**TITLE: KAHALGAON- ST I & II (4X210 MW + 3X500 MW) FGD**

**SPECIFICATIONS FOR RCC CHIMNEY**

SPECIFICATION NO. PE-TS-481-620-C002

**CLARIFICATION NO. CS-0011-  
109(4)-9-TECH-CLF-01**

NO. 0011-109(4)-POM-A-003  
REV. NO. B

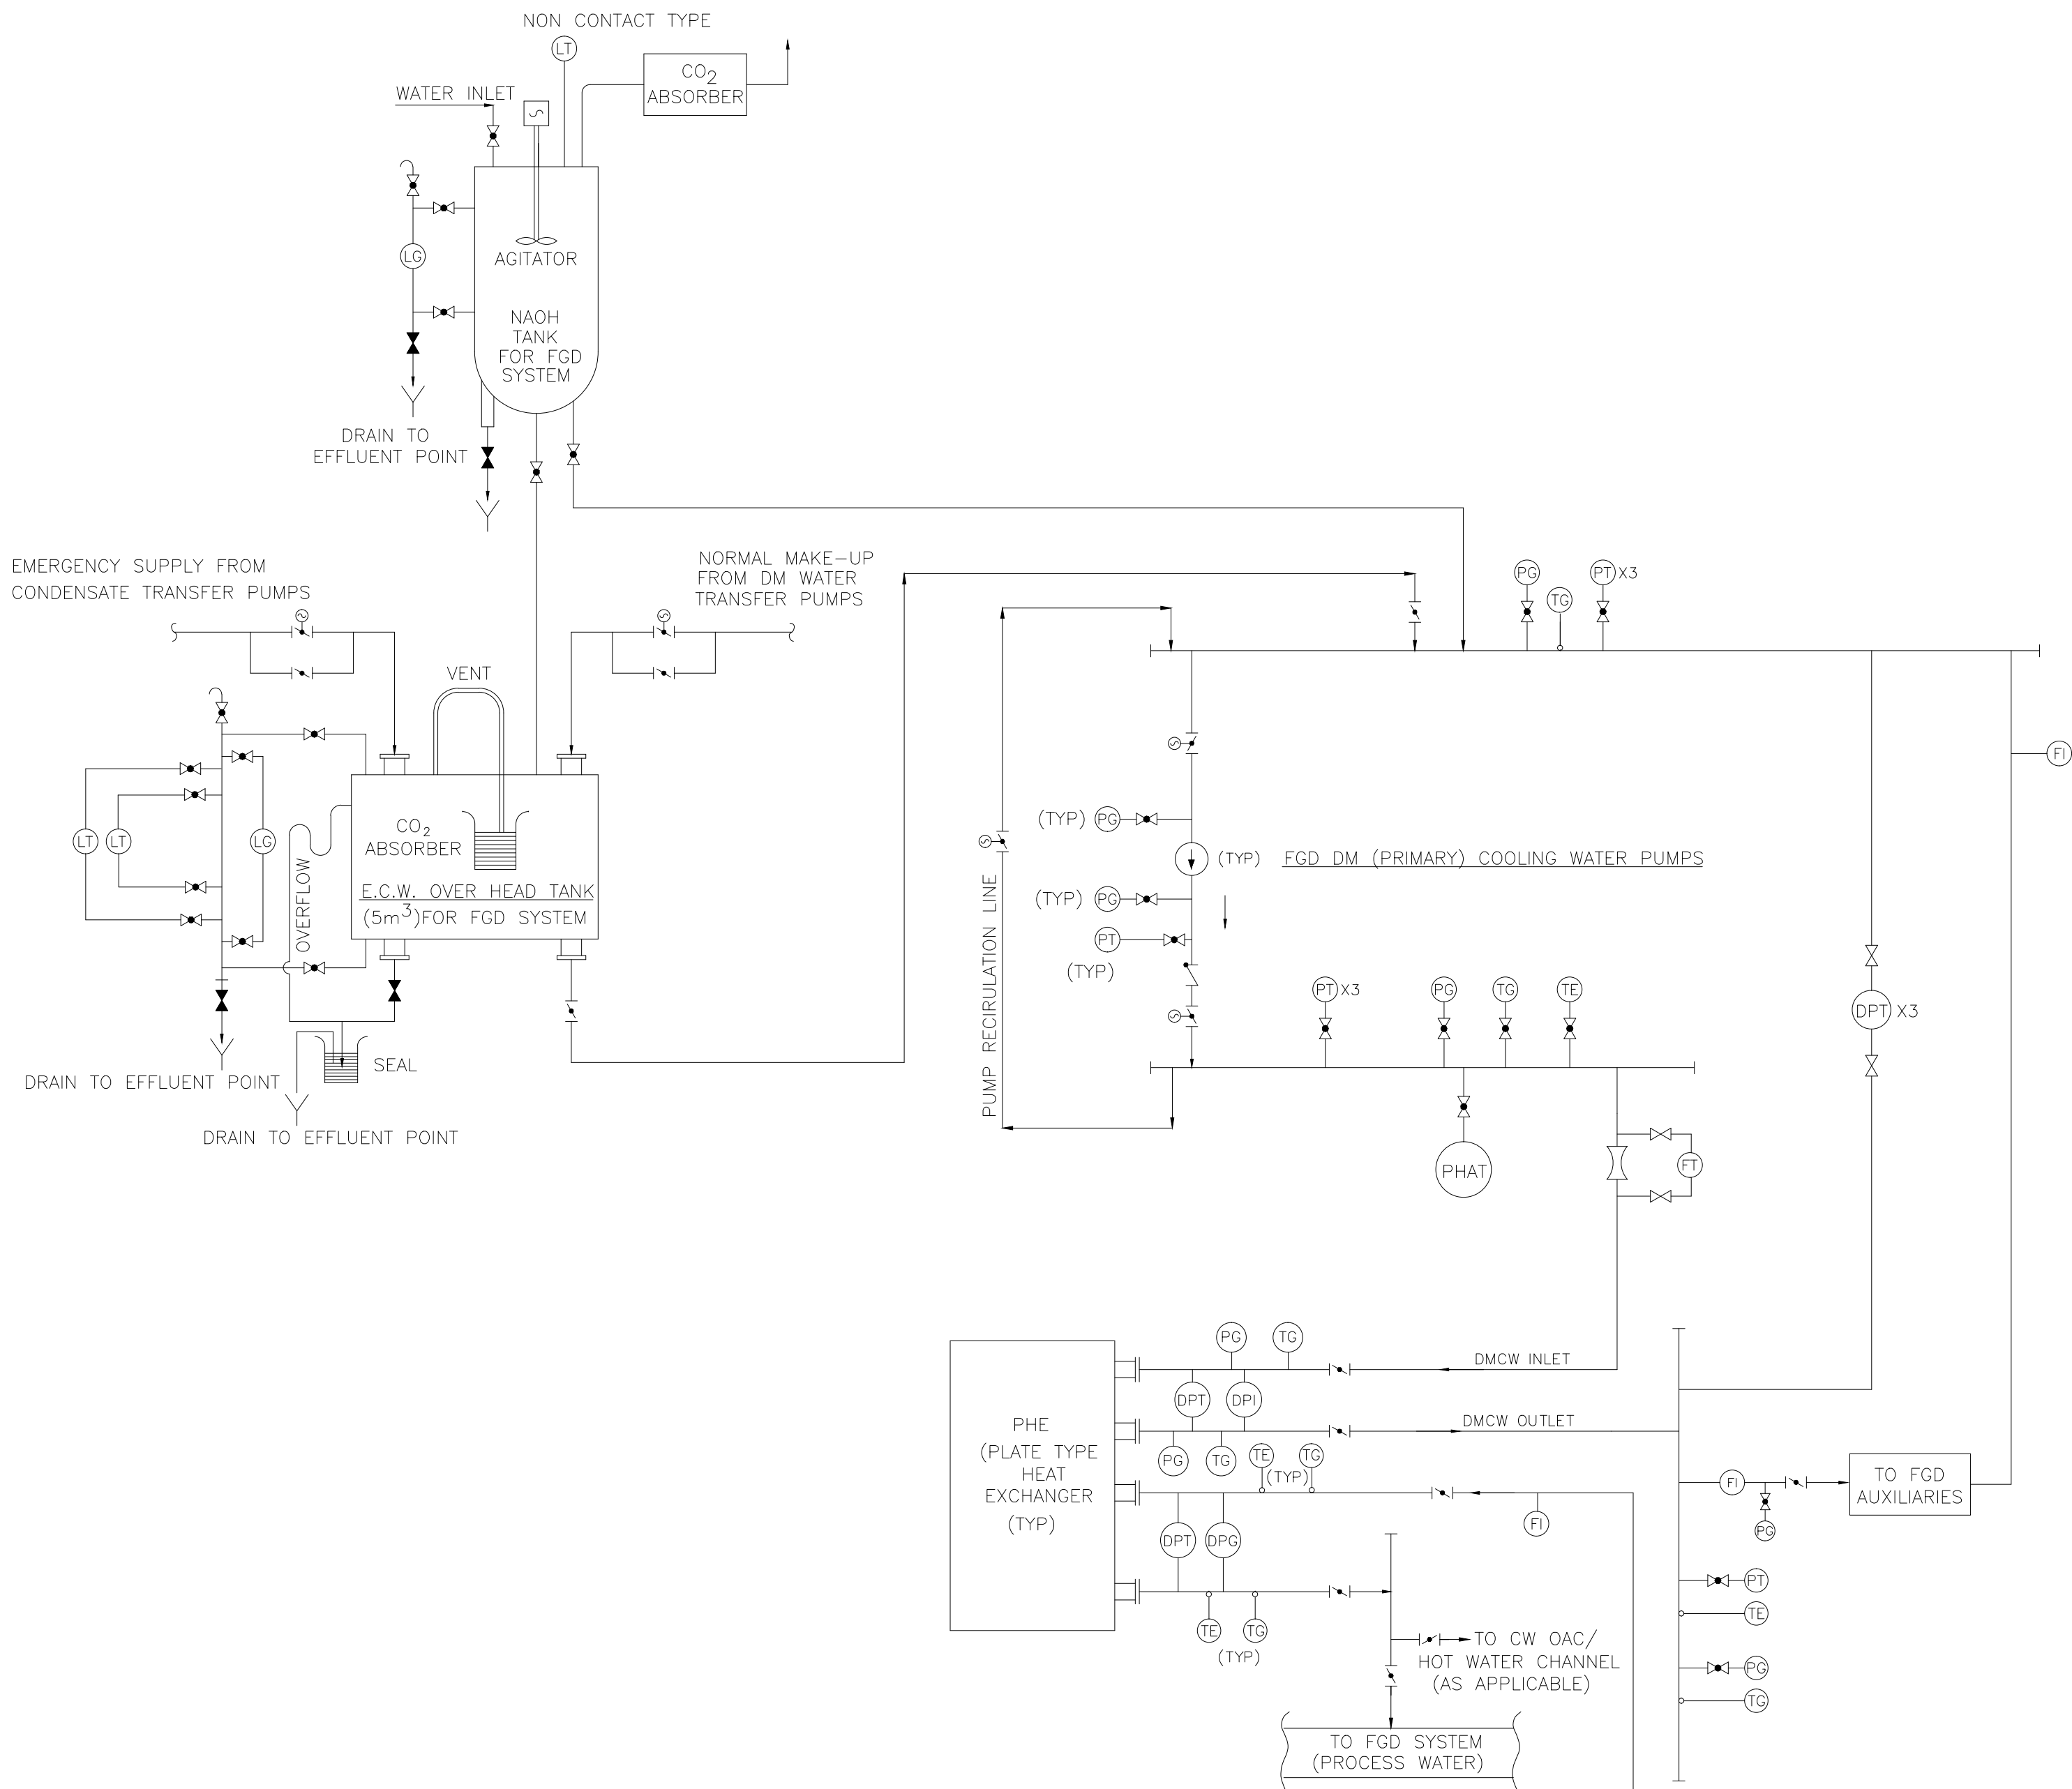
9.	VI/ E	Tender Drawings 0011-109(4)-POM-A-001	Sheet no. 2 of 3		SO2 analyser and Flow transmitter cum Indicator (FT+FI) shown in Flue gas duct between absorber and chimney.	SO2 analyser and Flow transmitter cum Indicator (FT+FI) shown in Flue gas duct between absorber and chimney stands deleted.

SIZE A2	SCALE	DRG.NO. <b>0011-109(4)-POM-A-004</b>	REV. B
------------	-------	-----------------------------------------	-----------

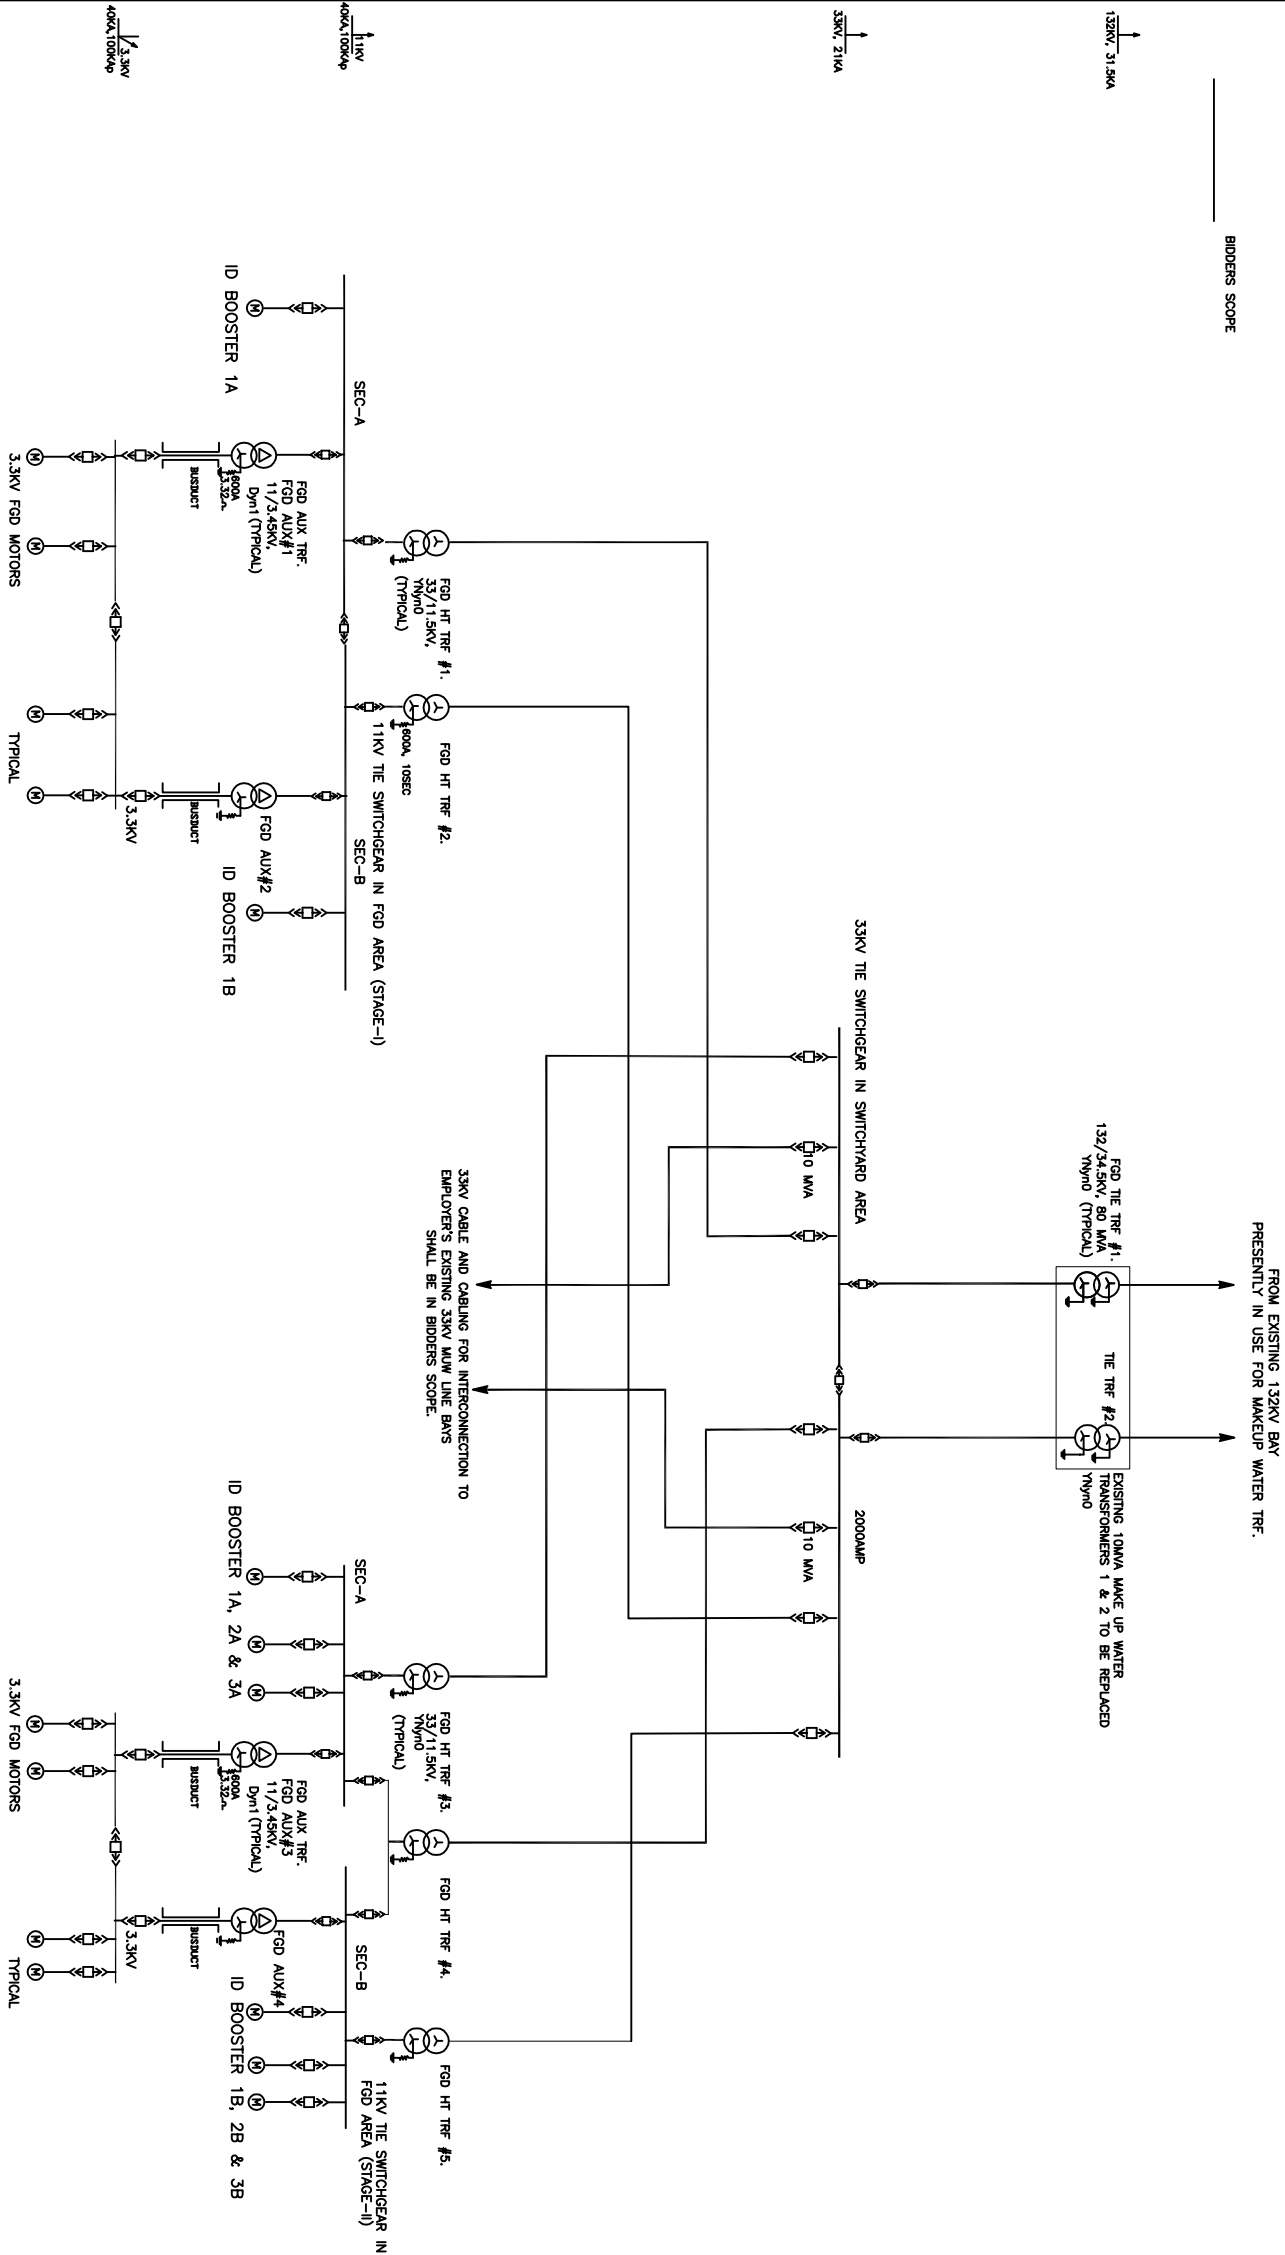
SL. NO.	SPECIFICATION REFERENCE				SPECIFICATION REQUIREMENT	COMMENTS / CLARIFICATIONS	NTPC REPLY
	SEC/ PART	SUB SEC.	PAGE NO.	CLAUSE NO.			
516.	VI/E	DRAWING : 0011-109(4)-POM-A-004, P&ID for ECW system for FGD system package			<p>P&amp;ID for ECW system for FGD svstem packade</p> <p><u>FGD AUXILIARY (SECONDARY) COOLING WATER PUMPS</u></p> <p>TOTAL NUMBER OF PUMPS = TOTAL NUMBER OF UNITS + 2 NUMBER (AS COMMON STAND BY)</p> <p>TOTAL NUMBER OF PHE = TOTAL NUMBER OF UNITS + 1 NUMBER (AS COMMON STAND BY)</p> <p><u>FGD DM (PRIMARY) COOLING WATER PUMPS</u></p> <p>TOTAL NUMBER OF PUMPS = TOTAL NUMBER OF UNITS + 1 NUMBER (AS COMMON STAND BY)</p>		Bidder is requested to comply the specification requirement.
